CITY FACILITIES ARCHITECTURAL SERVICES DIVISION

DATE: March 23, 2007

## ADDENDUM NO. 1

## FOR THE CONSTRUCTION OF THE JOHN J. MONTGOMERY MONUMENT AT YERBA BUENA

JOHN J. MONTGOMERY MONUMENT MONUMENT SUB SLAB DETAIL DRAWING NOT TO SCALE 3.23.07

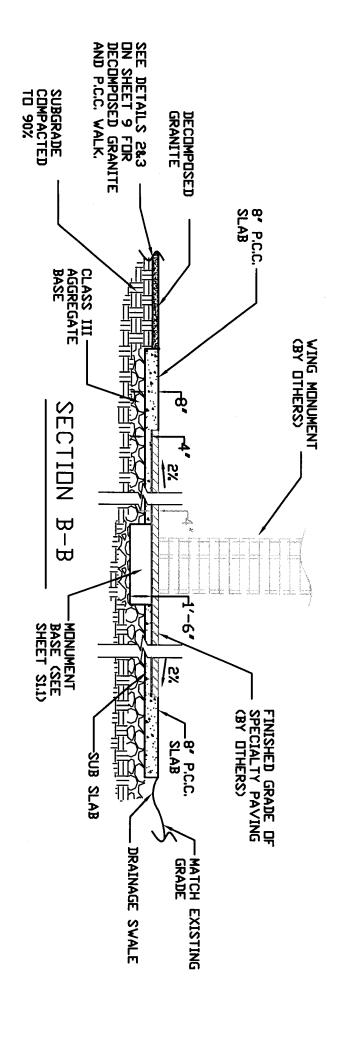
- B) SHEET 6, SECTION B-B: See attached detail for monument sub slab.
- 2. **SHEET 10, DETAIL 2**: **ADD** note that trash receptacle shall be on a P.C.C. Pad. The pad dimensions shall be 4'x4'x 3 ½" thick.
